NUCLEAR POWER

Response to Environmental Permitting Regulations 2016 Schedule 5 Notice, Issued 11/12/2018

Application number: PAN-002427

Document Number: HNP-HZCON-PAC-REP-00011

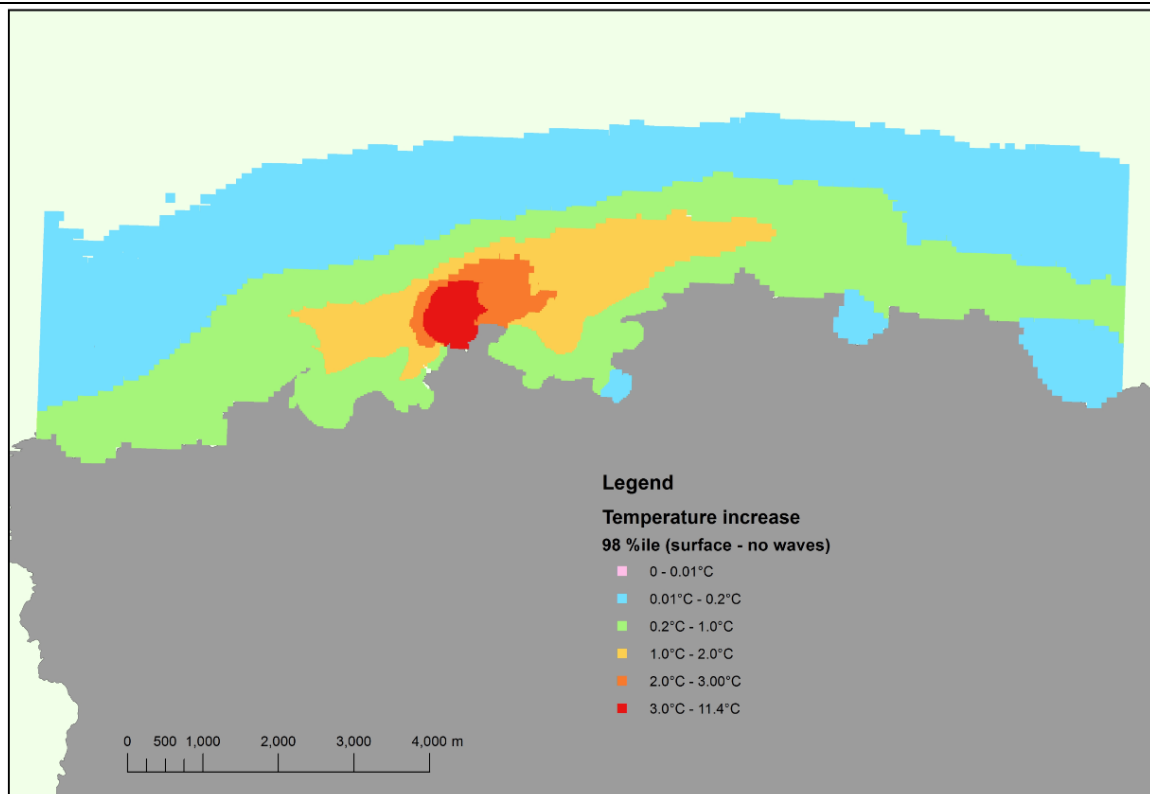
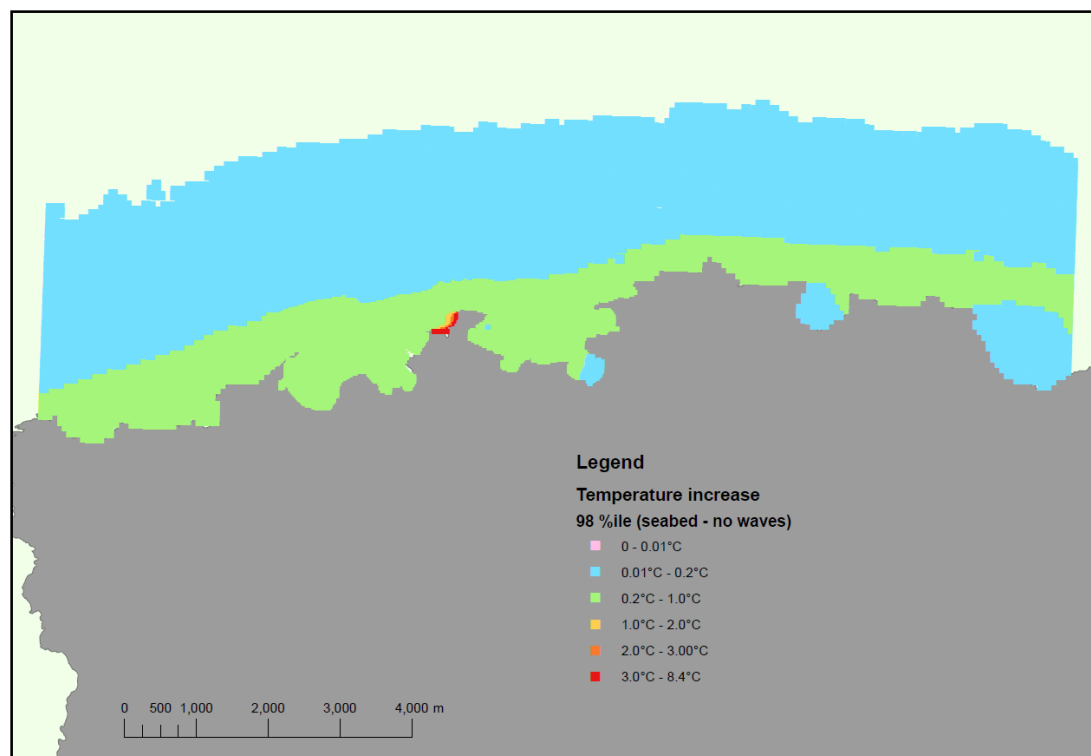
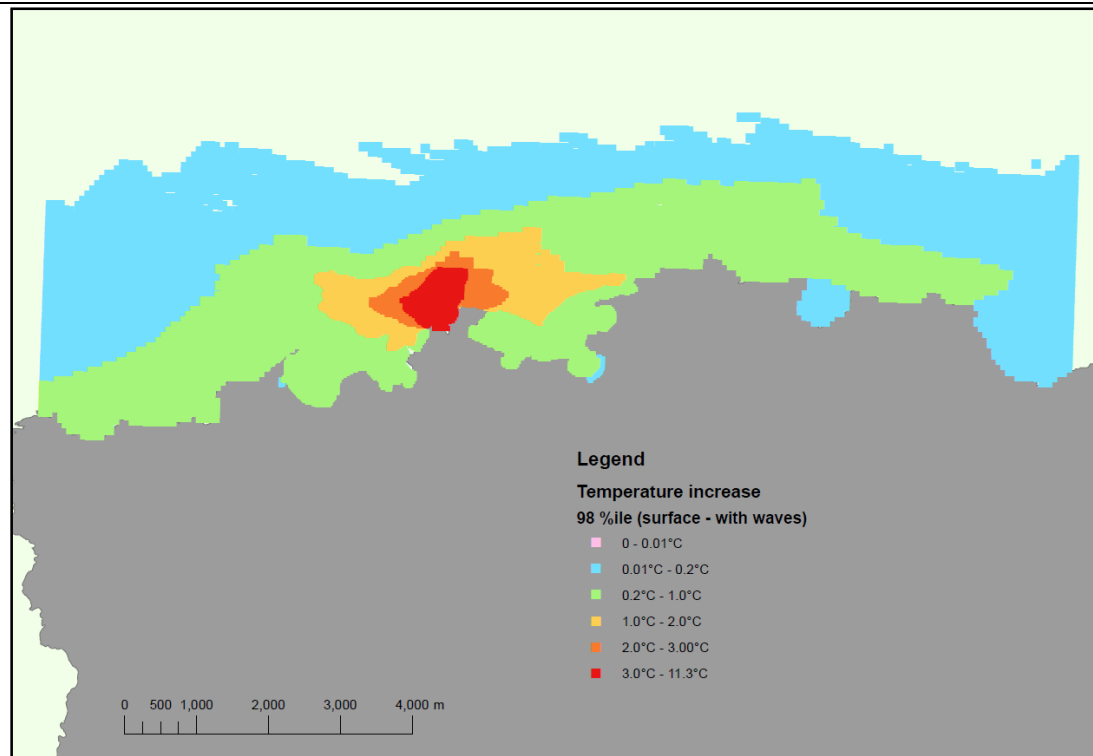
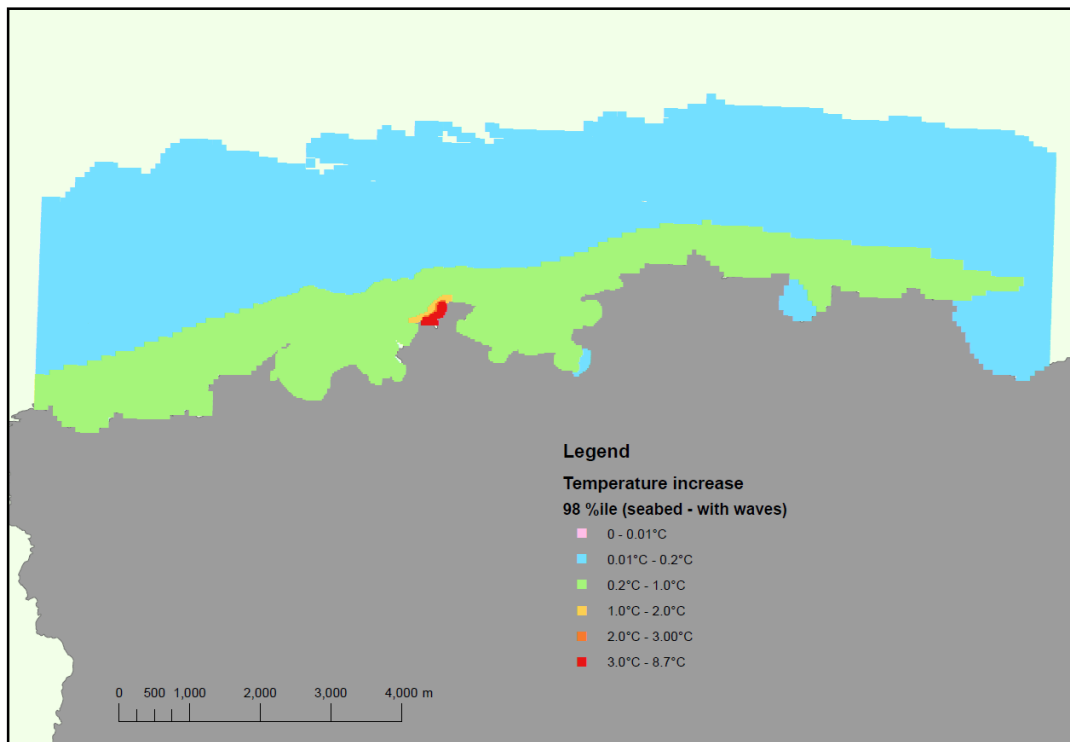
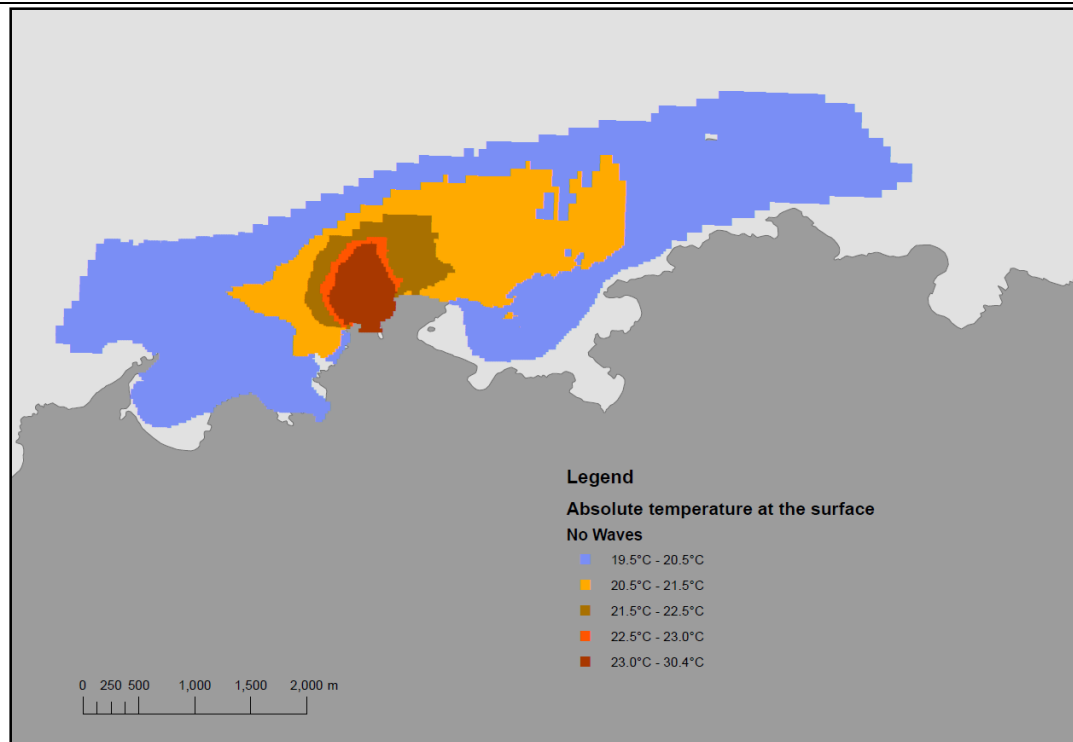
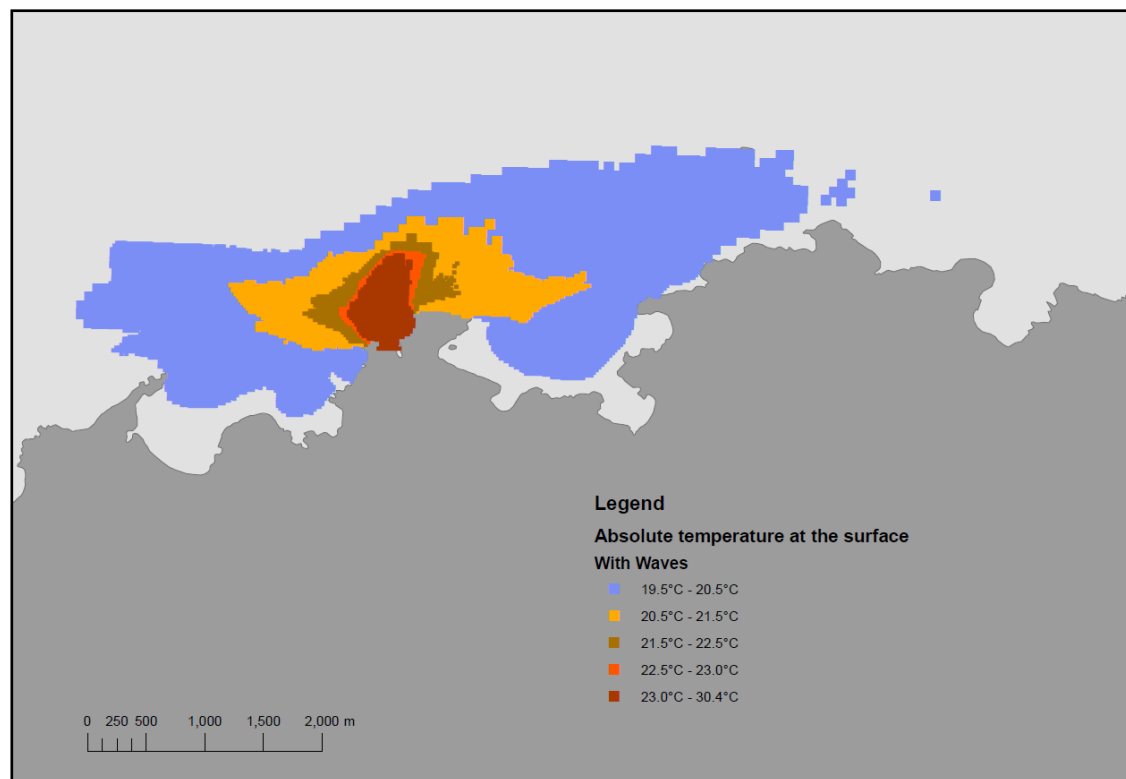
4.2 Scenarios should be considered which include the impacts of climate change. To remain consistent with the wave modelling climate change scenarios, you must show what the potential impacts are in 2087 from reasonably foreseeable and credible maximum climate change scenarios. You must show changes due to climate change to the: hydrodynamics, thermal plume extent, stratification and impacts of the cooling water discharge on the marine environment. Information on the thermal plume extent should be in line with request 1.1.

The resulting thermal plume contours are presented below for ΔT at both surface and bed, as well as absolute temperature at the surface only (with and without waves, baseline of 16.7 °C), in line with response 1.1. The areas of sea surface of 23°C and above for with and without waves are 0.29 and 0.33 km², respectively.
